IMPROVEMENT PERMIT DENIAL

Re: Application for improvement Permit for property located at 10125 Truelight Church Road, Parcel #137-161-03

SOIL/SITE EVALUATION for ON-SITE WASTEWATER SYSTEM

PROPOSED PLOT PLAN

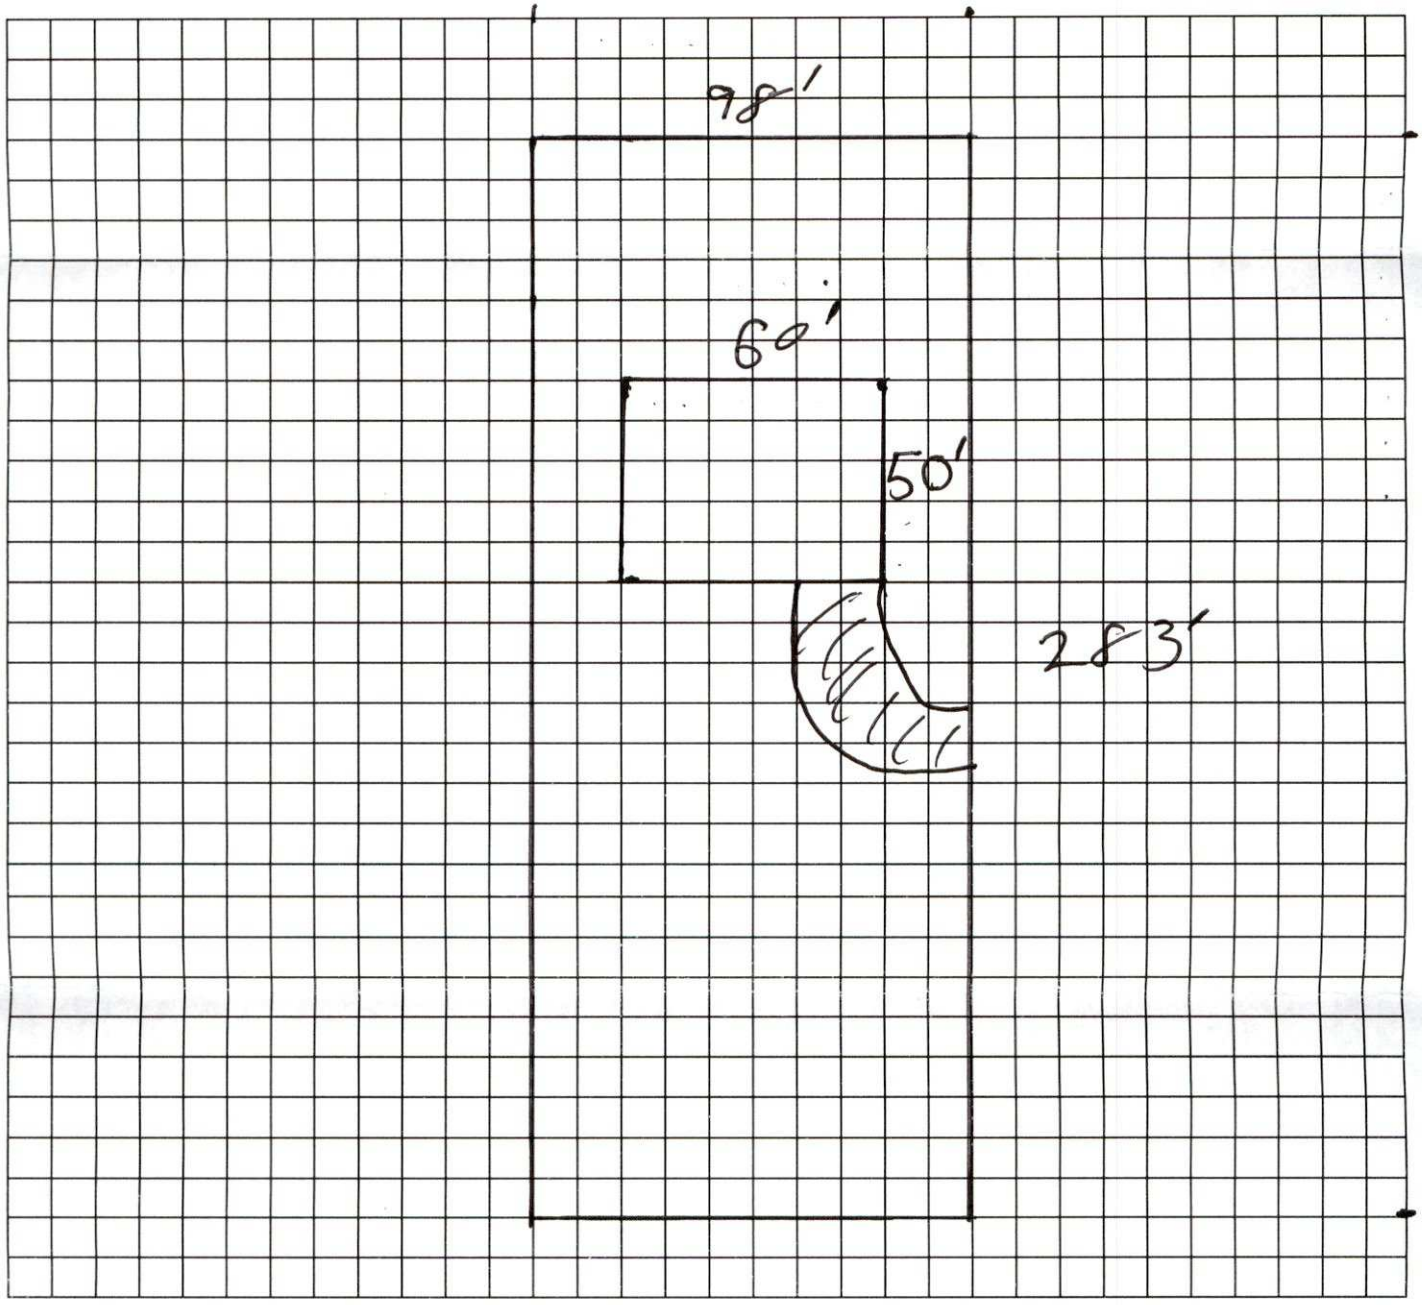
Based on the criteria set out in 15A NCAC 18E .0501 through .0602, the evaluation indicated that the site is **UNSUITABLE** for an on-site wastewater system. Therefore, we must deny your request for an Improvement Permit. A copy of the site evaluation is enclosed. The site is unsuitable based on the following:

- ☐ Unsuitable soil topography and/or landscape position (Rule .0502)
- ☐ Unsuitable soil characteristics (structure or clay mineralogy) (Rule .0503)
- ☒ Unsuitable soil wetness condition (Rule .0504)
- ☒ Unsuitable soil depth (Rule .0505)
- ☐ Unsuitable saprolite (Rule .0506)
- ☐ Presence of restrictive horizon (Rule .0507)
- ☐ Insufficient space for septic system and repair area (Rule .0508)
- ☐ Unsuitable for meeting required setbacks (Rule .0601 or .0602)
- ☐ Other (*Cite applicable rule*):_____

COMMENTS: *Deeper pit evaluations can be conducted to determine if there is any potential to reclassify the unsuitable soils & unsuitable saprolite to suitable. If the SCL Saprolite is reclassified to suitable, a deep system utilizing pretreatment may be a potential. Applicant did not want to provide the required pits to complete evaluation, therefore soil classification is Unsuitable.

The site evaluation included consideration of possible site modifications, as well as use of all possible systems approved under 15A NCAC 18E. However, the Health Department has determined that none of the above options will overcome the severe conditions on this site. A possible option might be a system designed to dispose of sewage to another area of suitable soil such as off-site to additional property.

A site classified as UNSUITABLE may be classified as SUITABLE if written documentation is provided that meets the requirements of Rule .0509(b) or (c). A copy of this rule is enclosed. You may hire a consultant to assist you if you wish to try to develop a plan under which your site could be reclassified as SUITABLE.
